Chapter 2 Response to Comments

2.3 Responses to Comments

Type SIR Supplemental EIR
Description The Recirculated Draft SEIR is a complete recirculation of the Draft SEIR released on June 16, 2017. The significant new information in the Recirculated Draft SEIR centers around the evaluation of the operation of the terminal from 2008-2014 under the set of mitigation measures approved in a previously certified 2008 EIR, to the extent those were implemented, and its continued operation in the future under new and/or modified mitigation measures, along with an incrementally higher cargo throughout level compared to that assumed in the 2008 EIR. The analysis examines whether potentially new significant environmental impacts or substantially more severe impacts would occur in the areas of Air Quality, Greenhouse Gases, and Ground Transportation.

Figure 3. Contributions of major source categories to project-level 2014 annual emissions of (a) NOx, (b) PM_{2.5}, (c) DPM emissions, and (d) PM₁₀ emissions.

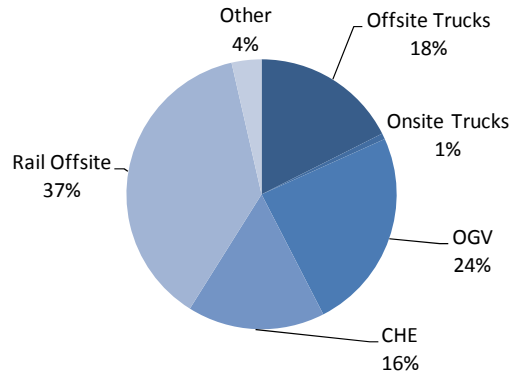
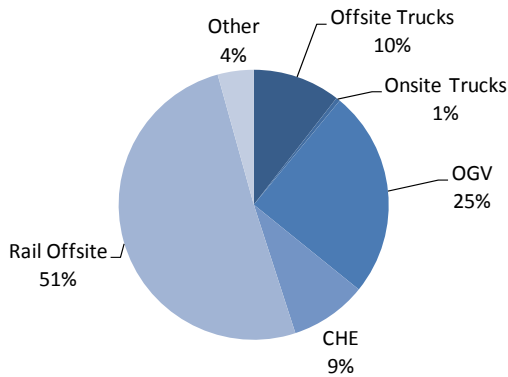
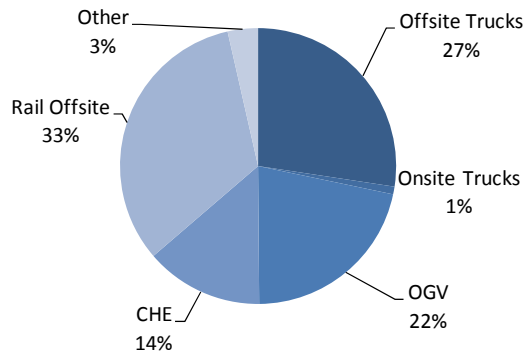
2014 baseline NOx emissions = 825 tons/yr

30 The first part of this comment (Figure 3, page 7 and 8) refers to material presented in a
31 previous draft (the DSEIR). That document has been superseded by the Recirculated
32 DSEIR, in which additional analysis years have been added to the air quality analysis and
33 peak-day emissions have been updated; accordingly, this part of the comment is no
34 longer applicable.

Figure 4. Comparison of alternative estimates of annual PM emissions from on-site trucks.

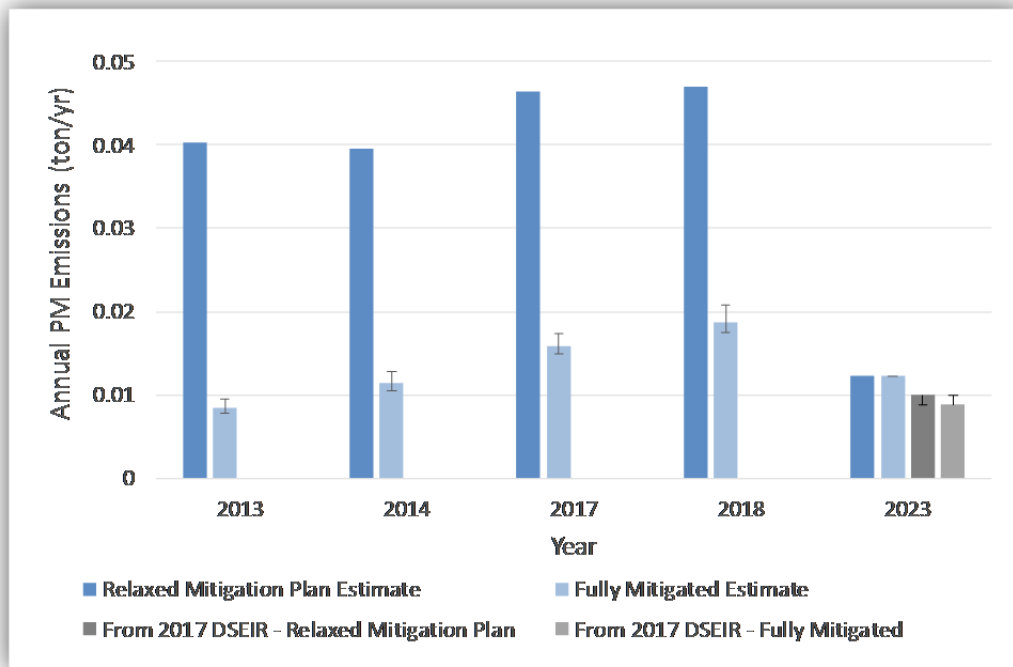
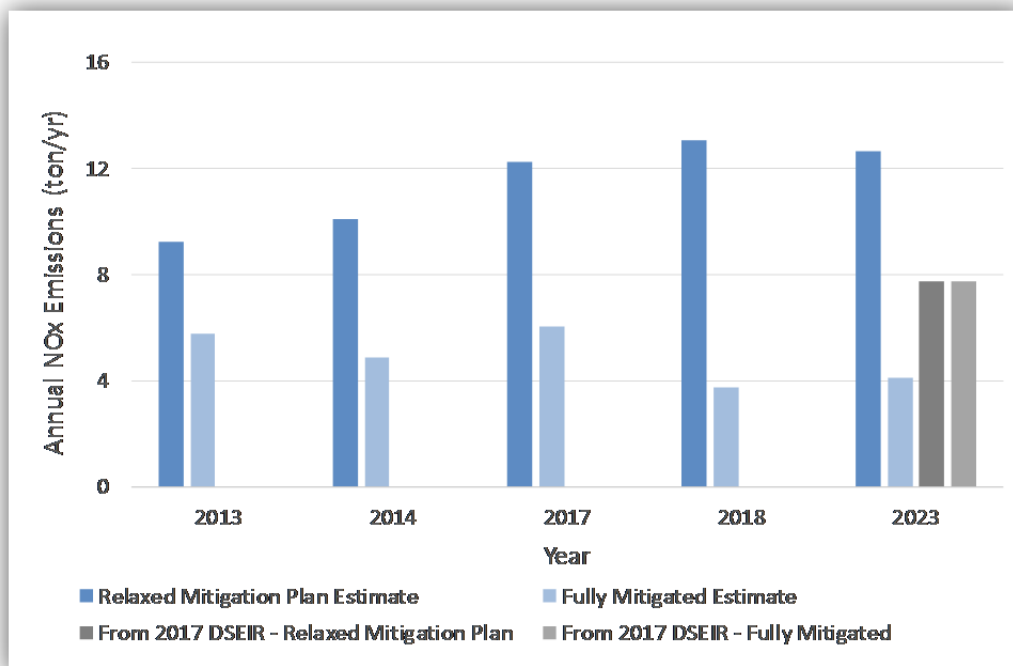
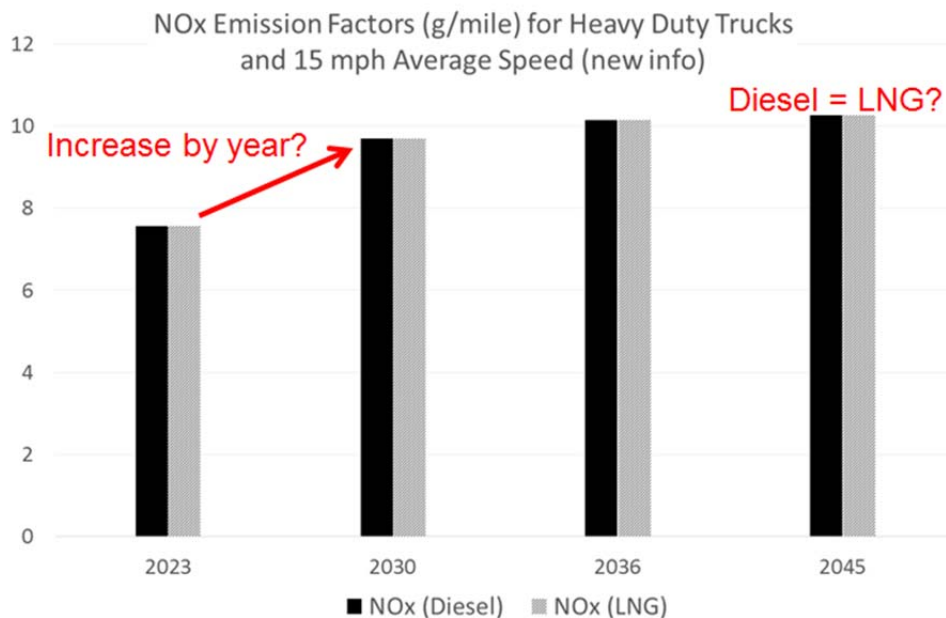
Figures 4 and 5 illustrate alternative estimates of project-level PM and NO_x emissions for heavy-duty trucks operating within the boundaries of the CS Container Terminal Project. Based on best available information, STI staff working under my direction prepared estimates of annual emissions for two scenarios⁵: (a) implementation of MMAQ-20 as approved (“Estimate - Fully Mitigated Plan” in the figures) and (b) implementation as proposed in the 2017 DSEIR (“Estimate - Relaxed Mitigation Plan” in the figures). These estimates cover several calendar years (2013, 2014, 2017, 2018, and 2023); and they are plotted alongside the analogous emissions estimates from the 2017 DSEIR for year 2023—i.e., the only comparable year covered in the 2017 DSEIR. **STI’s estimates show the excess emissions from heavy-duty trucks occurring, while the information from the 2017 DSEIR either omits (2013-2018) or even suggests no benefit from the approved mitigation plan in 2023.**⁶ Note that by ignoring years earlier than 2023, the 2017 DSEIR takes advantage of an EMFAC-projected conversion of the vehicle fleet in 2023 to modern emissions standards—after which time, diesel and LNG trucks are expected to emit PM at similar rates. In other words, federal or statewide regulations are expected to yield a large drop in PM emissions from diesel vehicles in 2023, regardless of which mitigation scenario is in effect at the CS Container Terminal. However, the lack of NO_x benefits projected for 2023 in the 2017 DSEIR is unsupported. LNG vehicles are known to emit NO_x at a much reduced rate compared to diesel vehicles. However, the **NO_x emission factors used in the 2017 DSEIR for heavy-duty trucks are contrary to published literature.** Not only are the emission factors for diesel-fueled trucks set to be equal to those for LNG-fueled trucks in the 2017 DSEIR, but the NO_x emission factors for heavy-duty trucks increase from 2023 to 2045 (see **Figure 6**). Both of these patterns are contrary to published literature.⁷

Figure 7. Comparison of various peak-day NO_x emissions scenarios for hoteling of OGVs as represented in the 2008 EIR and 2017 DSEIR.⁴

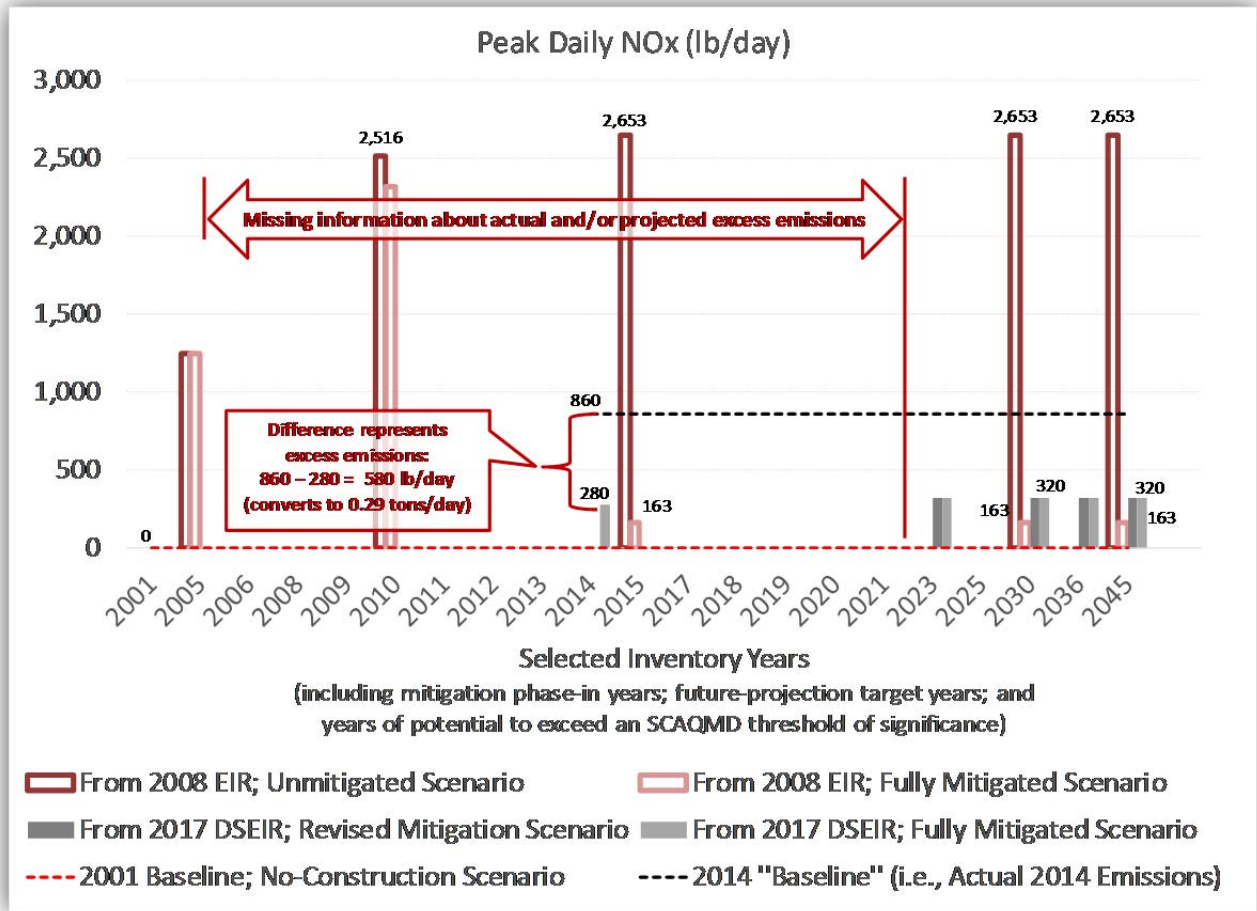
- The 2017 DSEIR failed to report the excess emissions from failure to comply with the approved mitigation measures related to hoteling of OGVs and cargo handling equipment.** Similar to our previous observation concerning the comprehensive project-level emissions inventory, information necessary to calculate excess emissions are not presented in the 2017 DSEIR during a critical period when approved mitigation measures were expected to gradually phase in (but didn't). Furthermore, we noted an inconsistency when reviewing the emissions for OGVs. [Figures 7 and 8](#) illustrate project-level, peak-day NO_x and PM_{2.5} emissions for hoteling of OGVs as presented in the 2017 DSEIR and 2008 EIR; and for comparison, [Figures 9 and 10](#) illustrate analogous *average-day* emissions. Under the revised mitigation measures plan proposed in the 2017 DSEIR, OGVs should be using alternative maritime power (AMP) during ship hoteling with a 95% compliance rate by 2018. Accordingly, the differences are expected to be small when comparing the approved mitigation plan and the relaxed mitigation plan for OGV emissions in years later than 2018. Figures 7 and 8 do show small differences in peak-day emissions post-2018; but Figures 9 and 10 show large differences and the reason for this inconsistency is unclear.

NRDC.I1-19

Figure 8. Comparison of various peak-day PM_{2.5} emissions scenarios for hoteling of OGVs as represented in the 2008 EIR and 2017 DSEIR.⁴

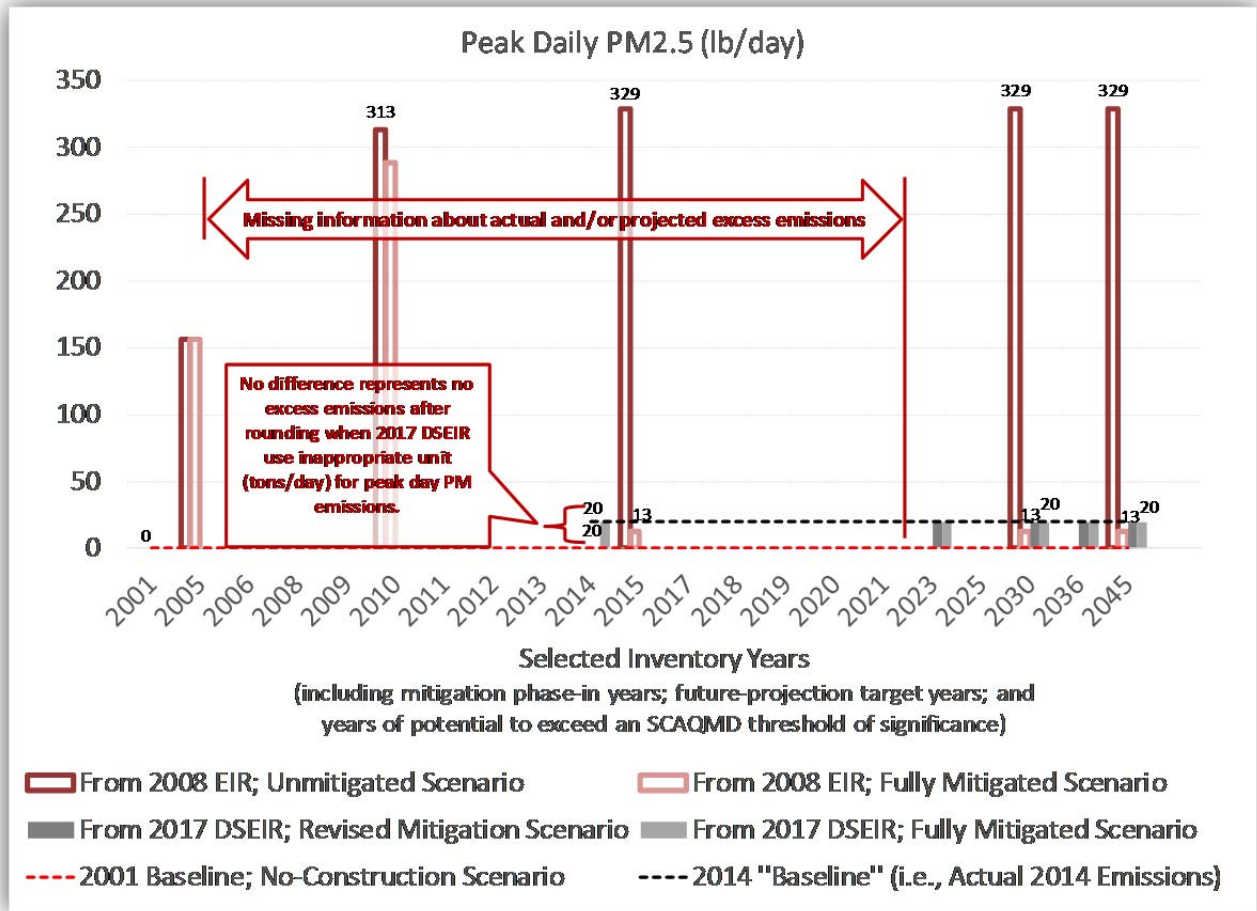
NRDC.I1-19

Figure 10. Comparison of various average-day PM_{2.5} emissions scenarios for hoteling of OGVs as represented in the 2008 EIR and 2017 DSEIR.⁴

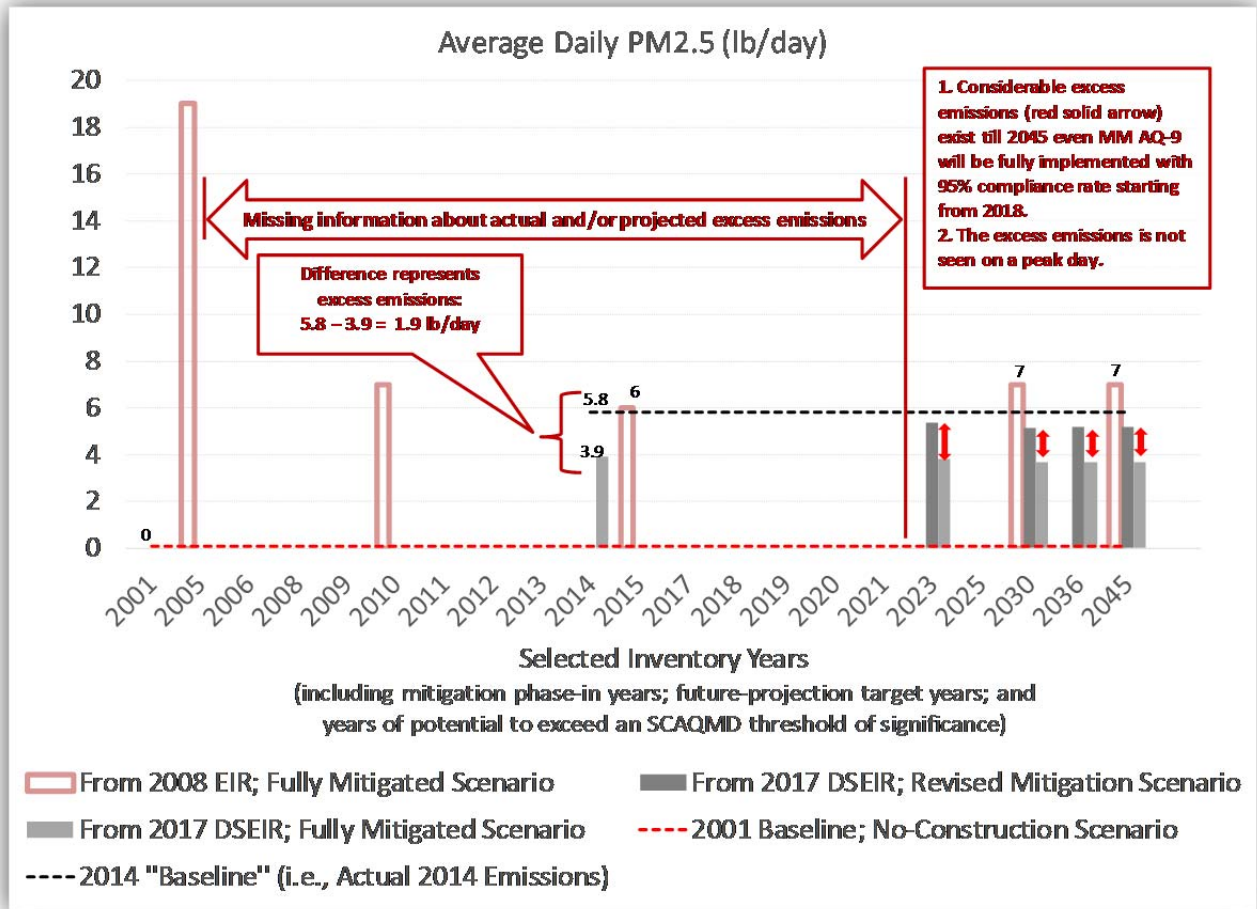
NRDC.I1-19

Figure 11. Comparison of various NO_x emissions scenarios for cargo handling equipment as represented in the 2008 EIR and 2017 DSEIR.⁴

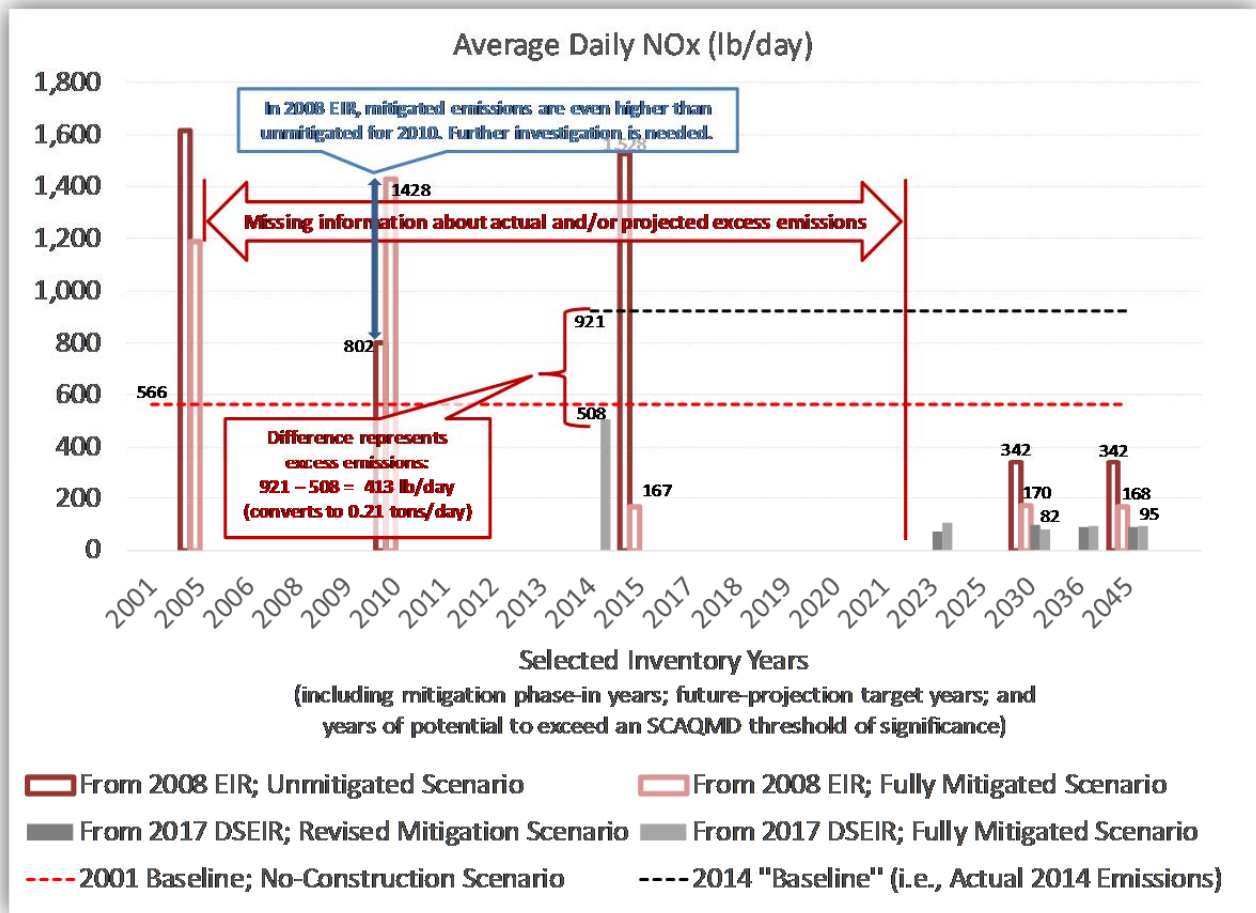
- Figures 11 and 12 illustrate project-level, peak-day NO_x and PM_{2.5} emissions for cargo-handling equipment. An inconsistency issue was found in the 2008 EIR for analysis year 2010 where emissions for the approved mitigation scenario are greater than the emissions for the unmitigated scenario. If emissions from the 2008 EIR are used as a basis for comparison, estimates for these two scenarios need to be verified.

NRDC.I1-20

Figure 12. Comparison of various PM_{2.5} emissions scenarios for cargo handling equipment as represented in the 2008 EIR and 2017 DSEIR.⁴

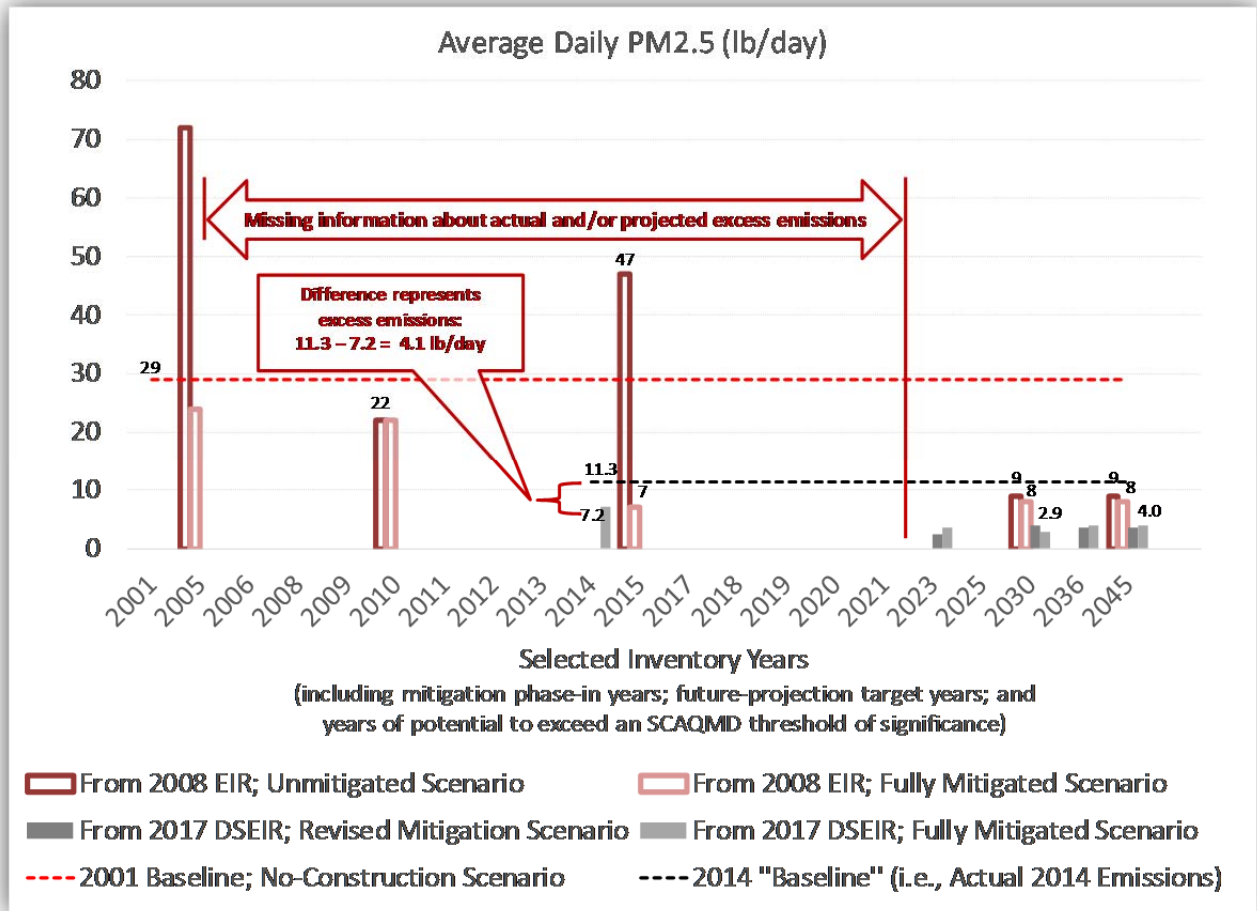
NRDC.I1-20
